September 23, 1997

SCI 133.009

**Work Plan**  
**Oil-Filled Manhole and Additional Investigation**  
**Ninth Avenue Terminal Study Area**  
**Port of Oakland**  
**Oakland, California**

**SITE PLAN**

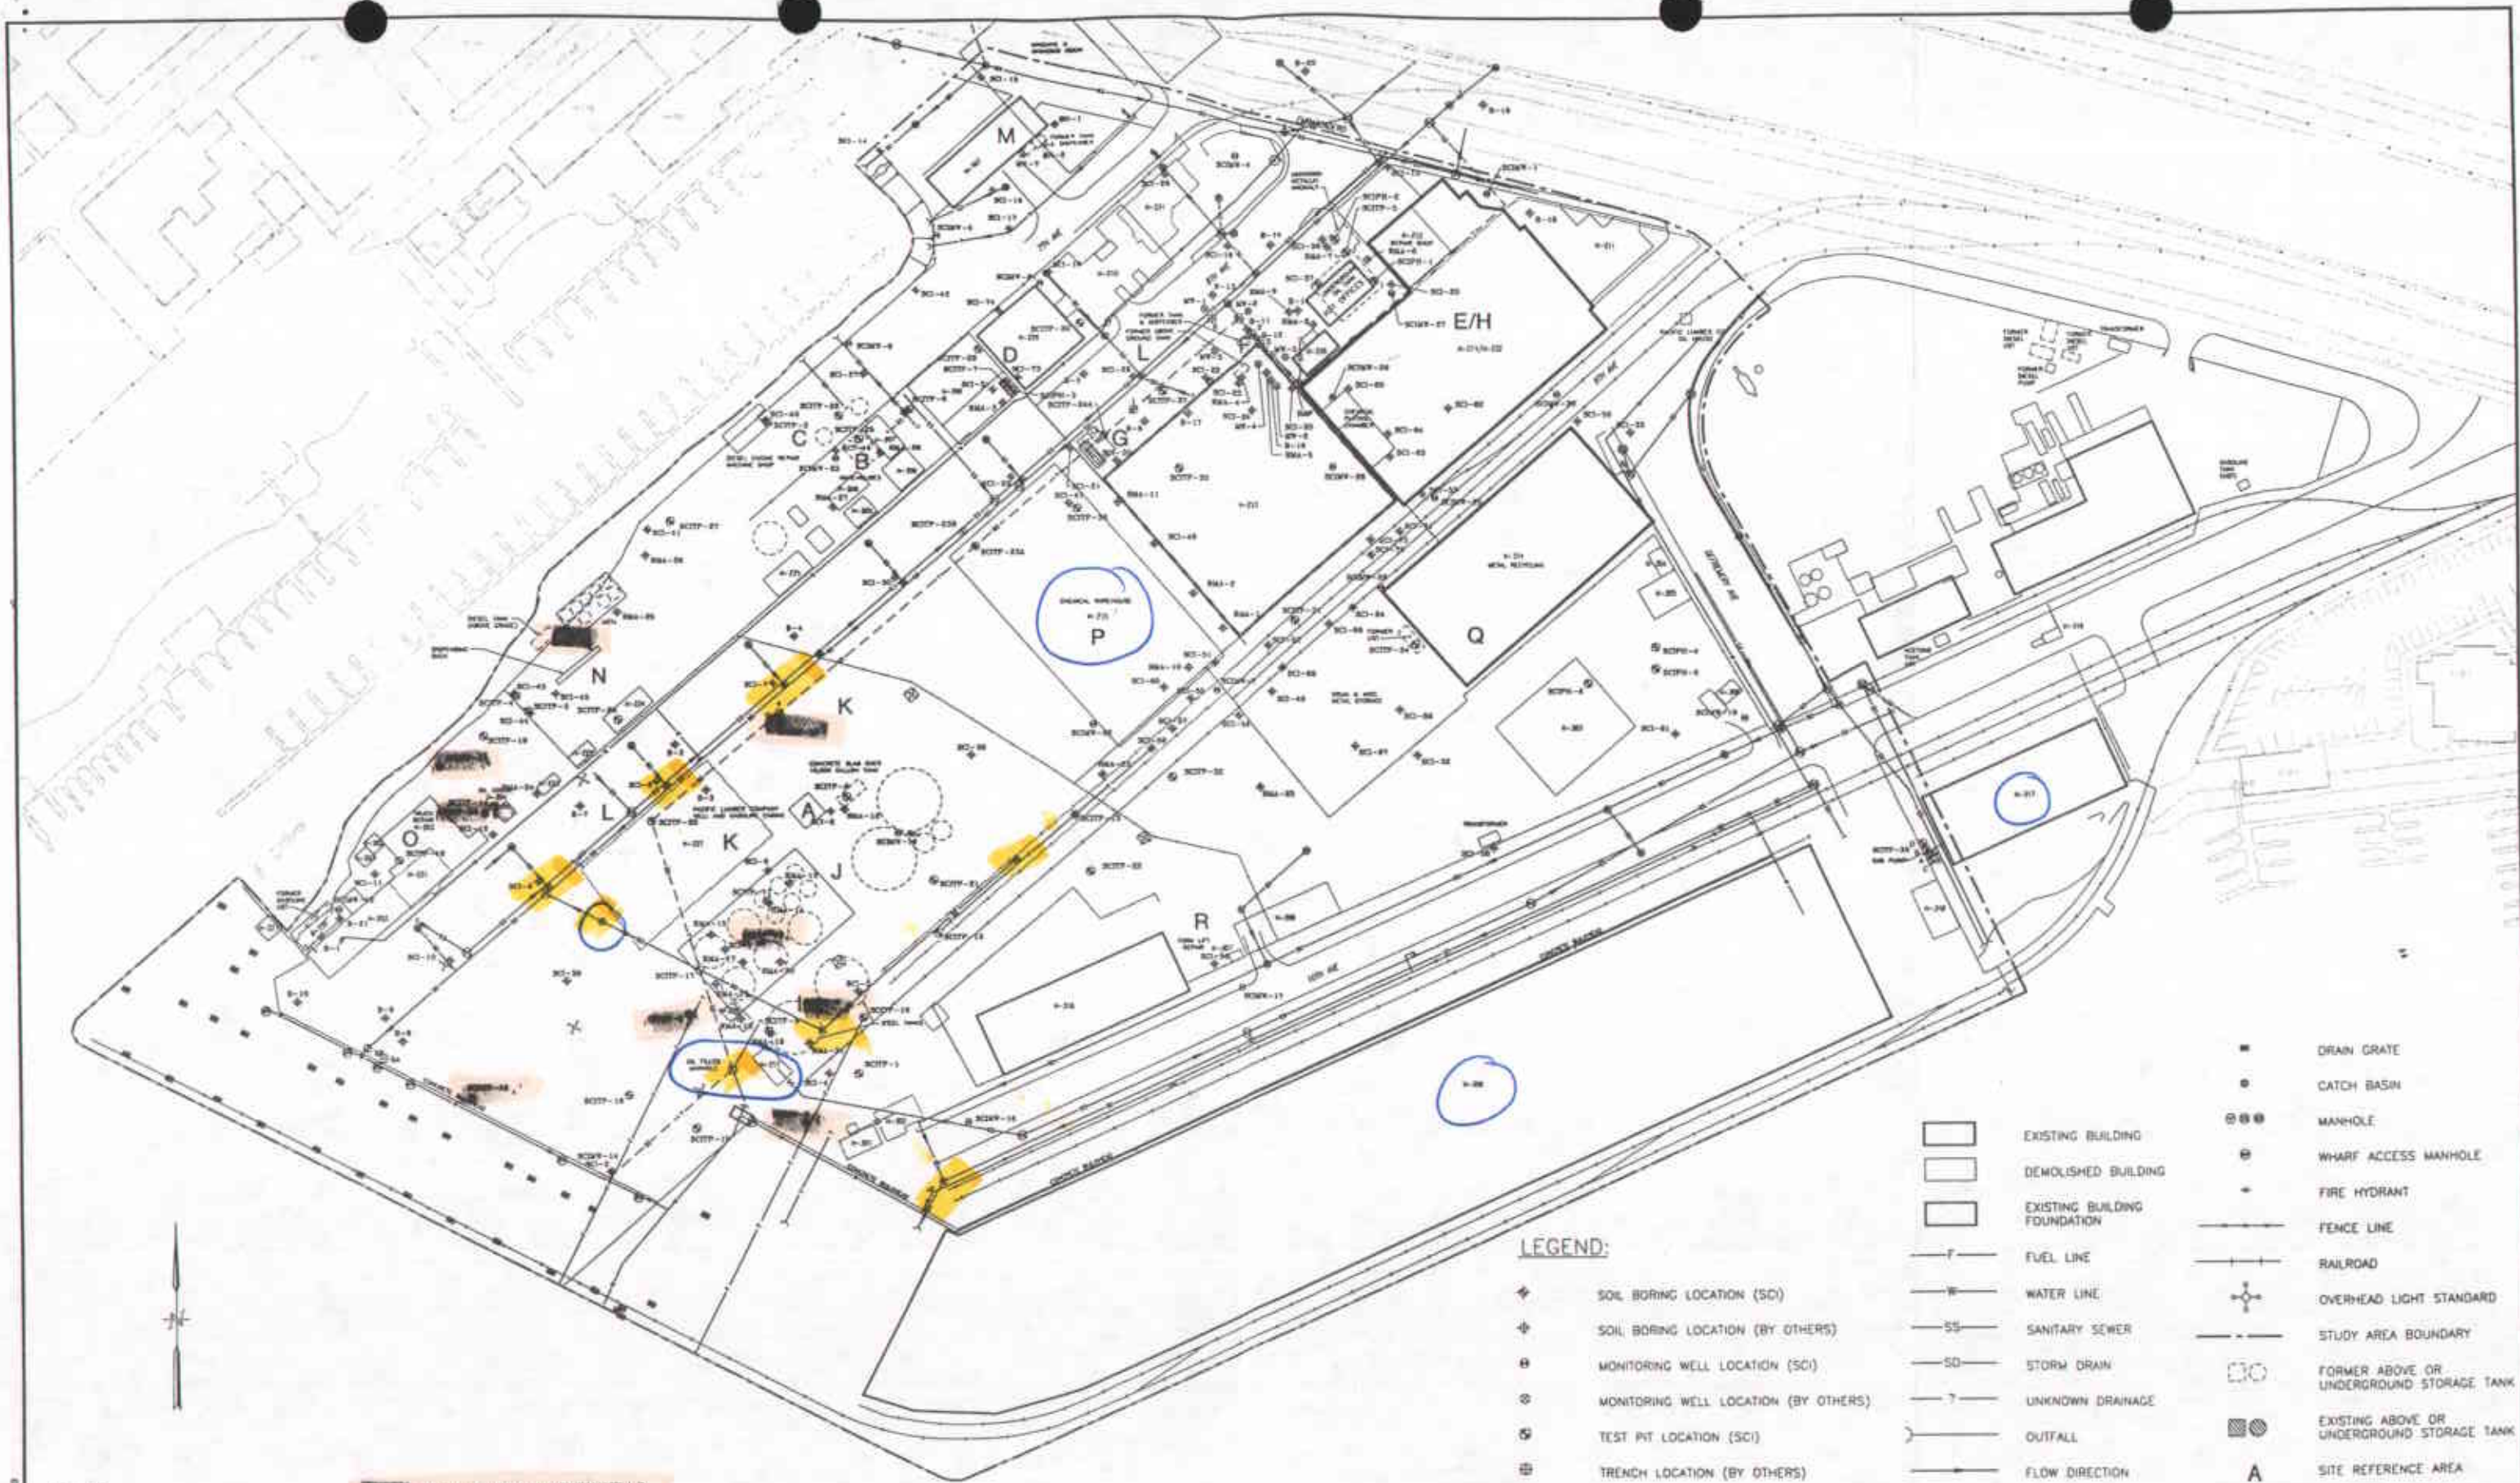
SCI will also drill a total of four test borings up to 15 feet deep in the locations shown on Figure 1 <sup>where's this</sup> using a cuttingless soil sampling technique known as Envirocore. A site reconnaissance conducted by SCI on September 11, 1997, provided information to locate the four borings. Two of the test borings will be located within and adjacent to Building H-317 near a discharge pipe for a suspected parts cleaning sink, and in the low-lying center of the building. The two other borings will be located adjacent to Building H-309 in an area of observed surface staining and in an unpaved location at the west end of the building where surface water runoff from the surrounding areas collects at a drain inlet.

*I Need to  
verify  
need..*
